Review of MLGW Transmission RFP and Thermal Generation RFP in reference to Memphis City Council Amendment #1 to Work Plan

EnerVision was requested to provide an assessment of MLGW’s compliance to the April 6, 2021 Resolution of the Memphis City Council in approving the MLGW contract with GDS Associates, Inc. to perform the RFPs following the Integrated Resource Plan. Specific to the Resolution were amendments to the work plan outlined in the preamble. **Amendment #1 to Work Plan** states “MLGW will make it clear in the RFPs issued that the three recommended portfolios from the Integrated Resource Plan are the desired scenarios but that bidders may include proposals for other methods of providing transmission and generation to Memphis and Shelby County.” The following is EnerVision’s assessment of compliance to the Resolution by the Transmission RFP and Thermal Generation RFP.

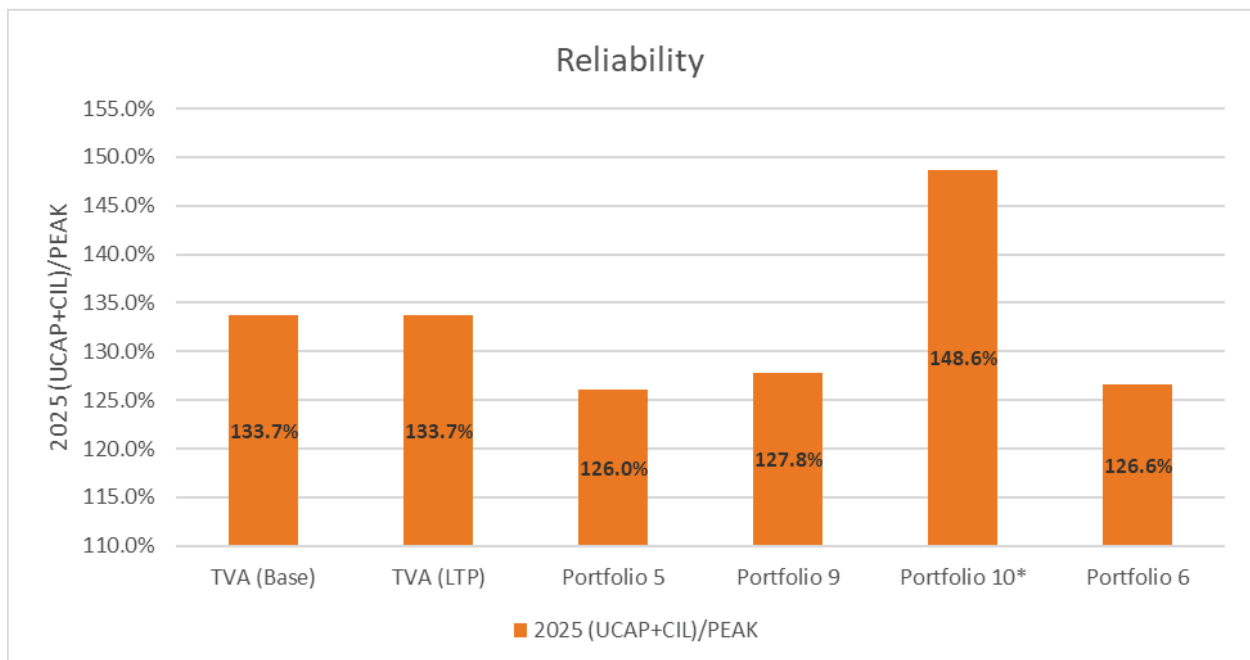
MLGW has determined that the most advantageous sites for the desired CCCT and SCCT generating plants would most likely be located on the east side of Shelby County where natural gas pipelines are prevalent (see Figure 1 below and Exhibit 76 of the Integrated Resource Plan Report).

RFP Respondent is responsible for design, permitting, construction, testing, operation and maintenance of the thermal project natural gas radial line from the main gas pipeline to the thermal project gas yard. Sites located near proposed electric transmission improvements may be also advantageous. Proposed plant interconnections should be limited to the points of interconnection (POIs) identified in Figure 2 below. **MLGW recognizes that the generating plant sizes requested may not be accommodated by MLGW's existing 161 kV transmission system. With that limitation in mind, any connections planned by RFP Respondents to MLGW's existing**
